**Z-35
(2016)**

CONCEPT PLAN FOR
EBENEZER CHASE
 LAND LOT 304 & 345, 16TH DISTRICT, 2ND SECTION
 COBB COUNTY, GEORGIA

PETITION NO.: Z-35

PETITION FOR: RSL

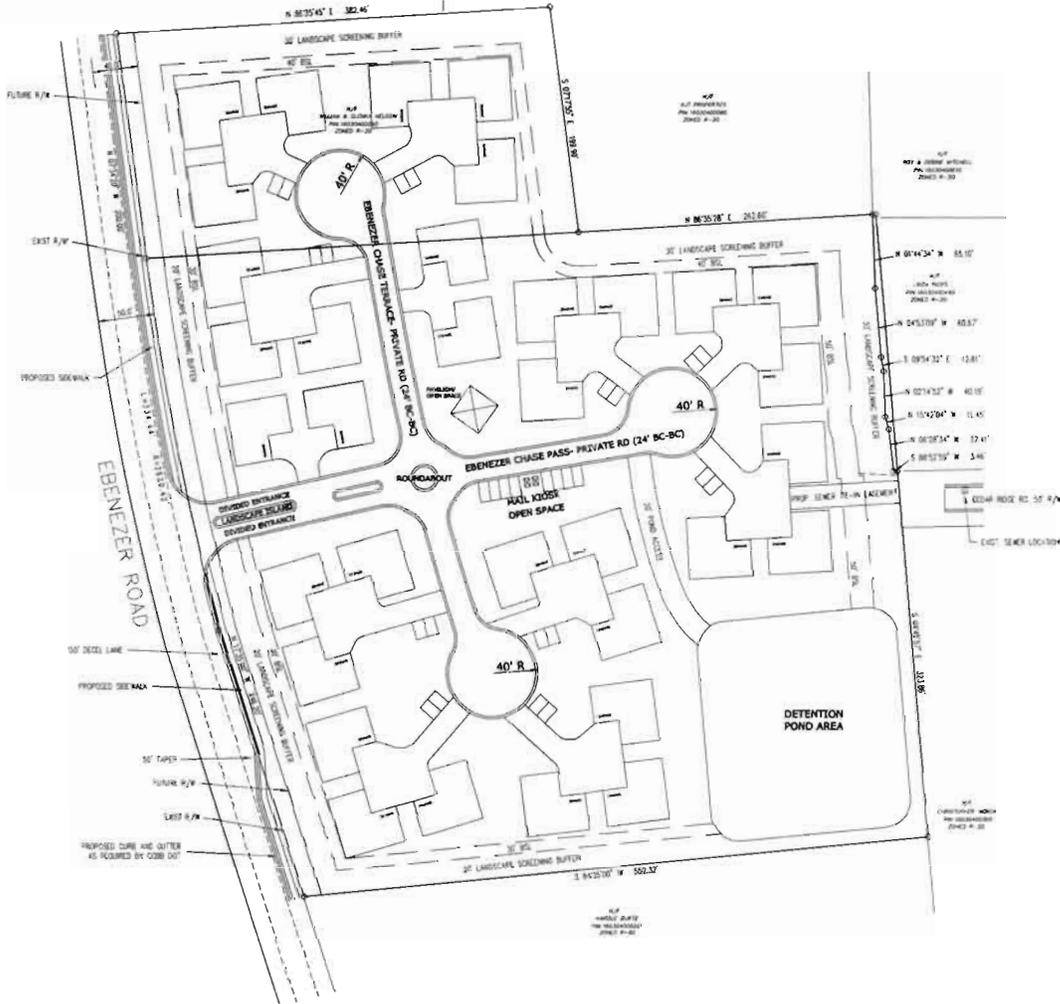
Applicant is requesting the Residential Senior Living (RSL) zoning district for the purpose of a non-supportive senior living development. The units will be detached. The units will be traditional one and a half stories, and will range in size from 1,750 square feet and up. Prices will range in from \$300,000 to \$450,000. The proposed development includes private streets and a pavilion. The site plan indicates the required 20-foot landscape buffer abutting more restrictive residentially zoned properties.

- No Stormwater controls shown _____
- Copy of survey is not current – Additional comments may be forthcoming when current site conditions are exposed.
- No site improvements showing on exhibit.

Revised Comments based on Site Plan received 5/18/2016

1. This site is located to the west of Ebenezer Road between its intersections with Blackwell and May Breeze Roads. It abuts Princeton Manor Subdivision to the north and North Ridge (aka Heritage Farms) Subdivision to the east and south. The site is primarily pasture with small wooded areas along the fence rows and the northern and southern boundaries. Average slopes on the site range from 5 to 15%. The majority of the site drains to the east into and through the North Ridge Subdivision via an existing channel platted as a drainage easement. A very small portion of the northwest corner of the site (1.3 ac) drains across Ebenezer Road to the Phillips Farm property to the west.

2. Development of this project will result in an increase in impervious coverage, storm runoff and non-point source pollution compared to build-out under the current single-family zoning categories. To mitigate, the First Flush Water Quality Best Management Practice Requirements must be elevated to the 1.5-inch rainfall event and each larger storm discharge controlled not to exceed the allowable discharge of the next lower, more frequent storm event (ie. 5-year storm event released at 2-year rate; 10-year event at 5-year rate; etc. to 100-year event at 50-year rate).

3. All current site runoff bypass into 1443 Cedar Ridge Road must be directed to the proposed stormwater management facility.

1. Board of Commissioners to approve final site plan, with the District Commissioner approving minor modifications;
2. Maximum density of 2.5 units per acre;
3. Water and Sewer Division comments and recommendations;
4. Stormwater Management Division comments and recommendations;
5. Department of Transportation comments and recommendations; and
6. Owner/developer to enter into a Development Agreement pursuant to O.C.G.A. §36-71-13 for dedication of system improvements to mitigate traffic concerns.
